CITY OF VANCOUVER

POLICY REPORT
DEVELOPMENT AND BUILDING

TO: Standing Committee on Planning and Environment
FROM: Director of Planning
SUBJECT: CD-1 Rezoning - 1845 Napier Street

NAME NAPIER LODGE REDEVELOPMENT 1845 Napier Street Vancouver, B.C.	DATE	CONSULTANT	APPROVALS [Signature Lines]
	DRAWN C.W.L.	[Signature]	
	CHECKED G.W.C.		
DRAWING NO. 4th FLOOR PLAN Vancouver, B.C.	SCALE 1/8" = 1'-0"	[Signature]

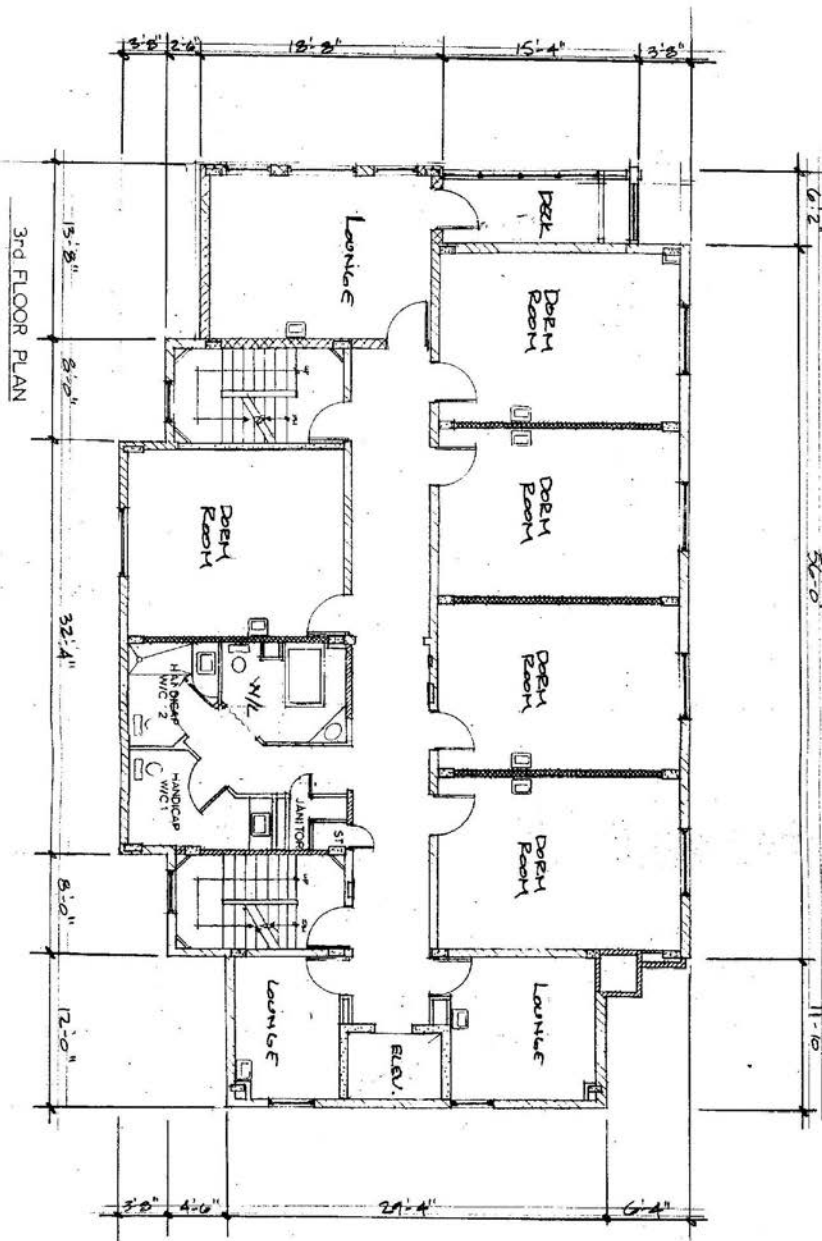
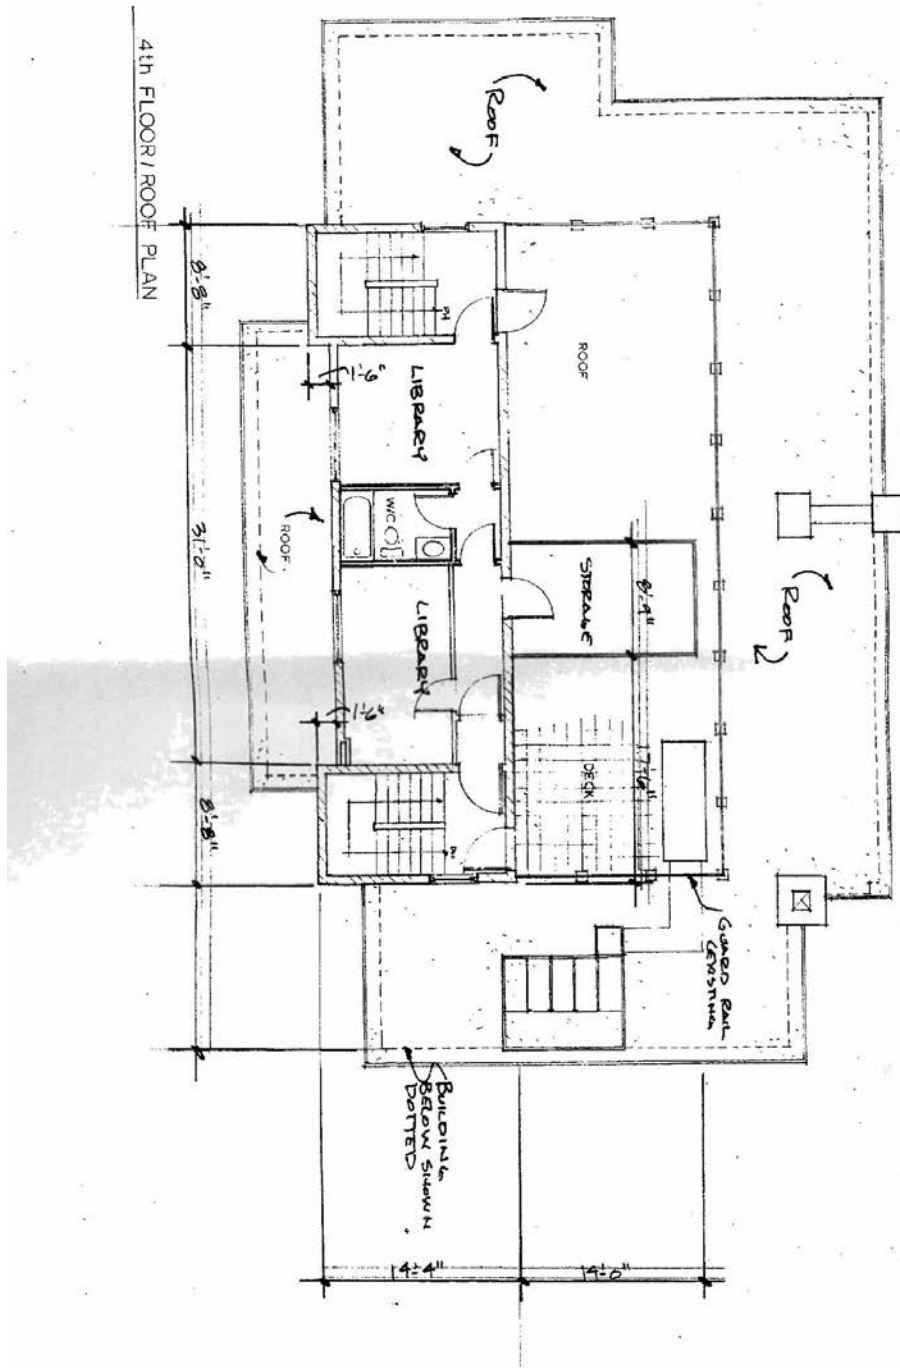
- (i) Design development to improve the exterior appearance of the building by painting or stuccoing the exterior wall.
- (ii) Design development to clarify the proposed storage area on the 4th floor and show on the elevation drawings.
- (iii) Clarify floor plans to show location of teaching areas and classrooms.
